TMI-11-103
October 18, 2011

Three Mile Island Nuclear Station, Unit 1
Renewed Facility Operating License No. DPR-50
NRC Docket No. 50-289

Subject: License Amendment Request to revise Technical Specifications to incorporate administrative changes

Figure 2.1-2

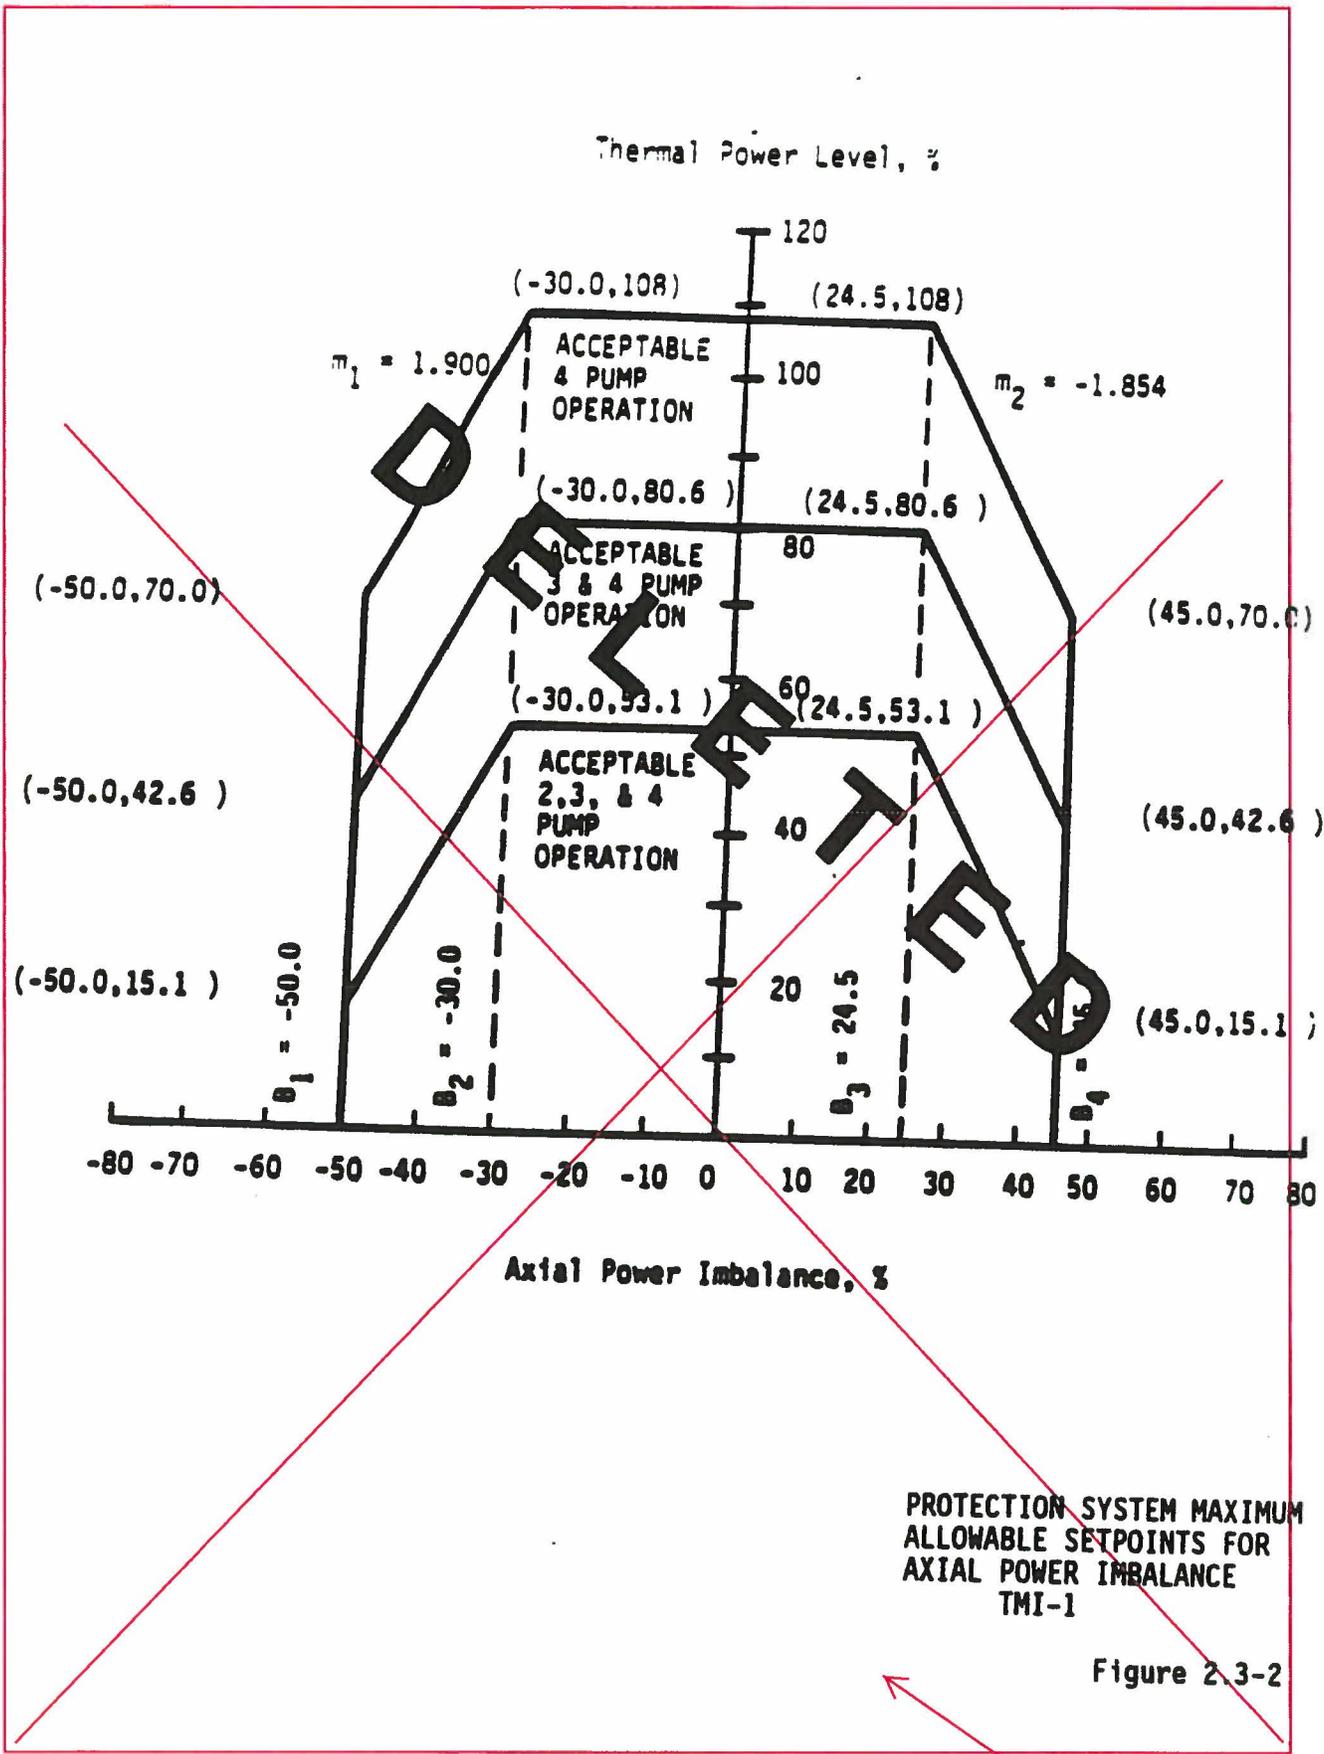
- TS 1.4.2, 1.4.3, and 1.4.4 on page 1-3 are edited to remove boldface formatting. The text in this section remains unchanged.
- TS Figure 2.1-2 on page 2-4b was deleted per Amendment 184; however, the page still exists in the TS with the word "DELETED" printed over the figure. Consistent with other figure deletions in TS (i.e., Figures 3.1-2a, 3.1-3, and 3.5-2a-l) page 2-4b is being replaced with a page containing only the words, "INFORMATION ON THIS PAGE HAS BEEN DELETED" and the footer.

INFORMATION ON THIS
PAGE HAS BEEN
DELETED

Figure 3.5-24

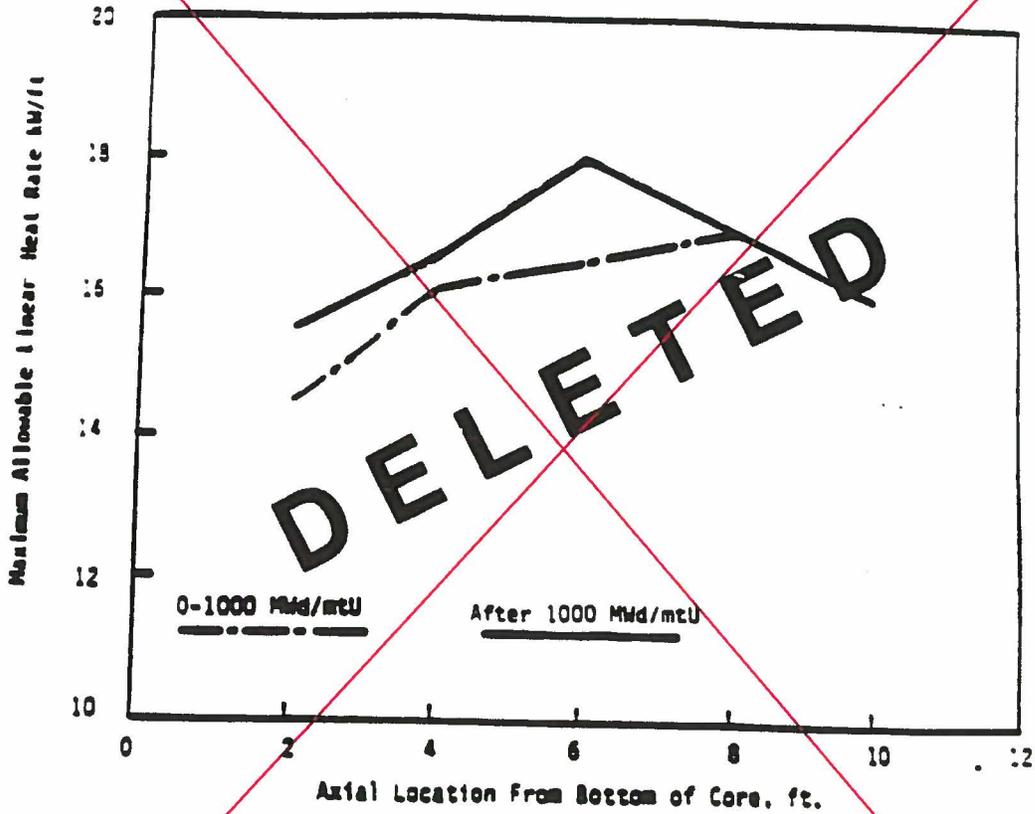
- TS 3.5.2.5.b.1 and 2 on page 3-35 are edited to remove an erroneous period (.).
- TS Figure 3.5-2M on page 3-36b was deleted per Amendment 168; however, the page still exists in the TS, with the word "DELETED" printed over the figure. To be consistent with other Figure deletions in TS (i.e., Figures 3.1-2a, 3.1-3, and 3.5-2a-l) page 3-36b is being replaced with a page containing only the words, "INFORMATION ON THIS PAGE HAS BEEN DELETED" and the footer.

AmerGen Three Mile Island Nuclear Station EXTENDED PLOT PLAN CAD FILE: 6717R1.DWG	FIG 5-1
---	---------

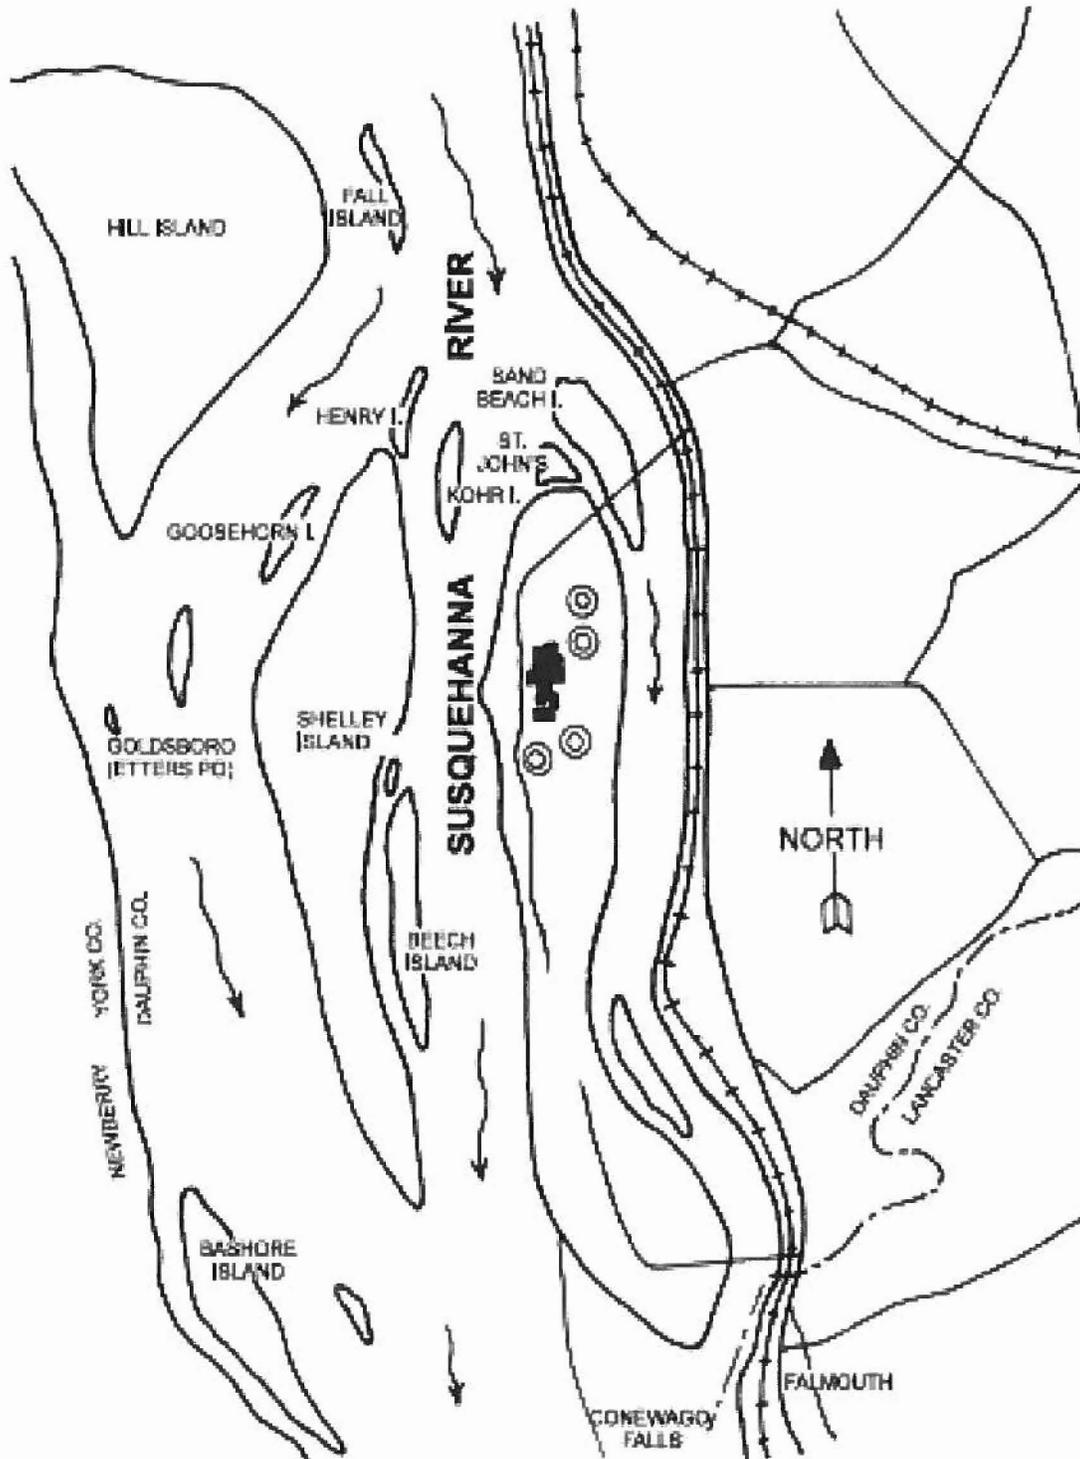
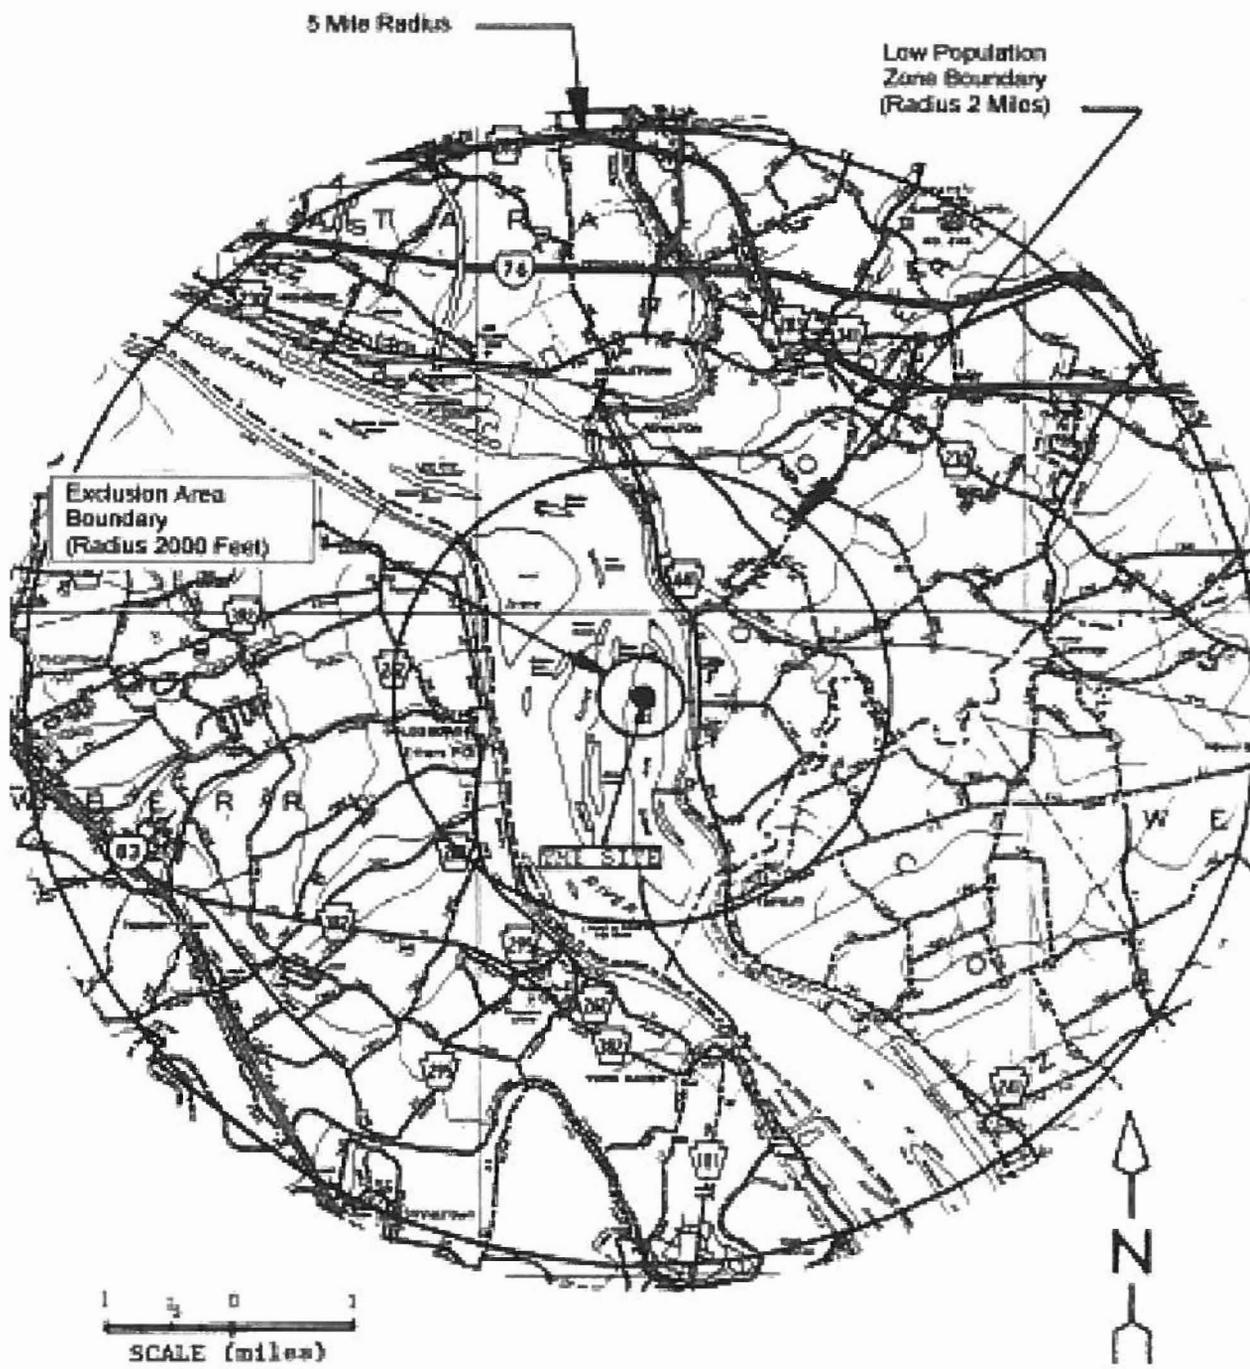
- TS Figures 5-1 through 5-3 are updated to provided clearer drawings and revise the drawing title boxes to reflect Exelon.

FIG 5-1
